SUBJECT: PUBLIC WATER SYSTEM NO. 360, PEARL HARBOR WATER SYTEM
SANITARY SURVEY REPORT

PEARL HARBOR WATER SYSTEM PWS 360
NAVY RESPONSE TO DOH SANITARY SURVEY OF NOV 2, 2009

SANITARY SURVEY OF THE PEARL HARBOR WATER SYSTEM

Photograph of stainless steel screen at combined overflow outlet for the Halawa storage tanks S-1 and S-2.

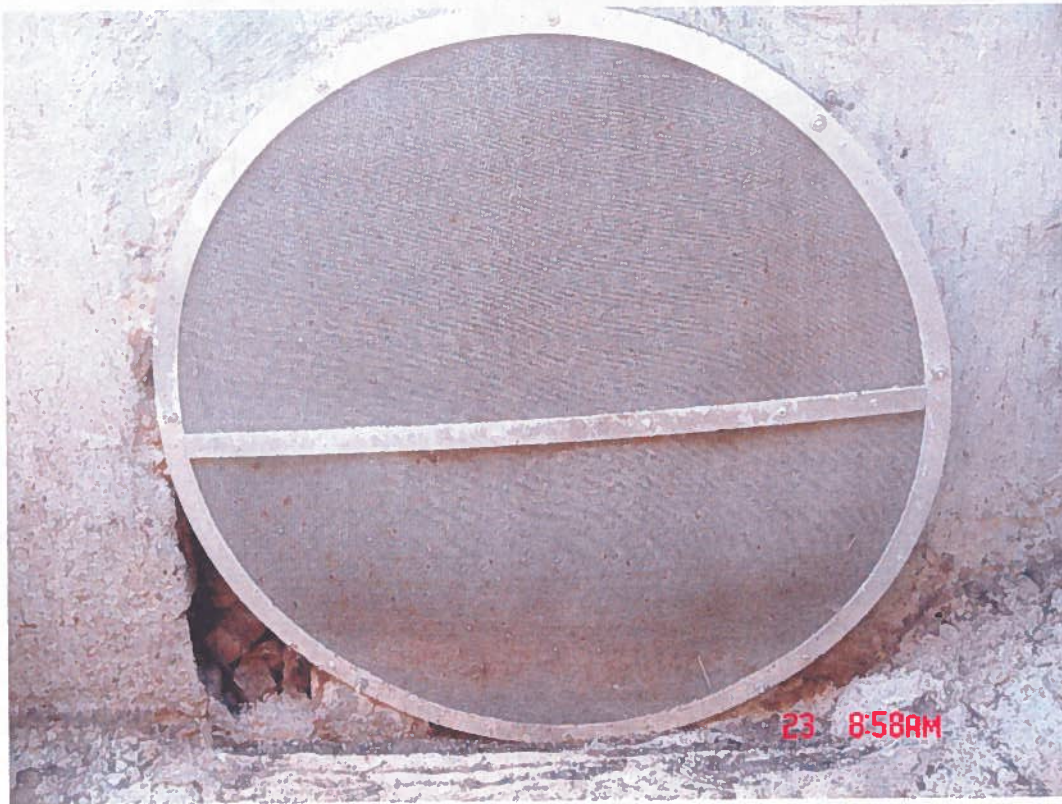
1. Halawa Storage Tanks S-1 and S-2
 - a. There are some areas of light rusting on the roof, sidewalls, and around the roof access hatch for both tanks. Recommend keeping a close eye on these rust areas and repair, resurface, and repaint as required.
 - b. The SDWB was not able to inspect the overflow outlet pipes for both tanks in order to verify the condition and if the outlets had either a screen or flapper valve. Recommend providing photo evidence of the outlets and installing either a stainless steel screen or flapper valve if needed.

Significant Deficiency	Corrective plan of action	Action Complete or Incomplete	Expected date of completion
n/a	NONE			
	DOH Recommendation	Corrective plan of action	Action Complete or Incomplete	Expected date of completion
1	<u>Halawa Storage Tanks S-1 and S-2:</u> There are some areas of light rusting on the roof, sidewalls, and around the roof access hatch for both tanks. Recommend keeping a close eye on these rust areas and repair, resurface, and repaint as necessary.	The tanks will be periodically checked. Repairing, resurfacing and repainting will be done, as necessary.	Ongoing	Ongoing
2	<u>Halawa Storage Tanks S-1 and S-2:</u> The SDWB was not able to inspect the overflow outlet pipes for both tanks in order to verify the condition and if the outlets had either a screen or flapper valve. Recommend providing photo evidence of the outlets and installing either a stainless steel screen or flapper valve if needed.	Halawa Storage Tanks S-1 and S-2 have a combined overflow outlet with a stainless steel screen. A picture of the stainless steel screen at the combined overflow outlet is provided on the following page.	Complete
